Product Change Notification

Change Notification #: 113813 - 00
Change Title: Intel® Server Chassis P4304XXSHCN
PCN 113813-00
Product Design, Label
Update the Safety label with an EAC logo instead of a GOST logo, Update the Front Panel Printed Circuit Board and Power Button LED, and Update Regulatory Labels
Date of Publication: April 21, 2015

Figure-1: Pre-Change

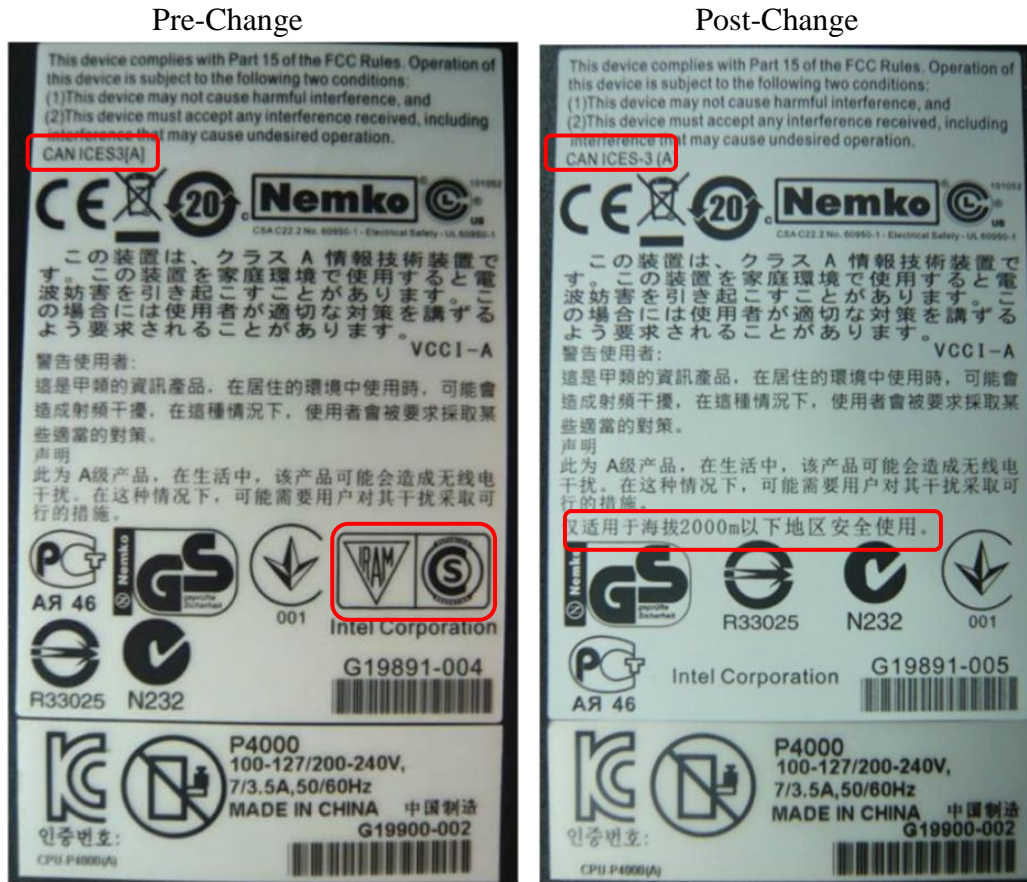
1. Update the Safety Label: Put an EAC logo instead of a GOST logo for certification update. Please see Figure-1 and Figure-2 below for details.
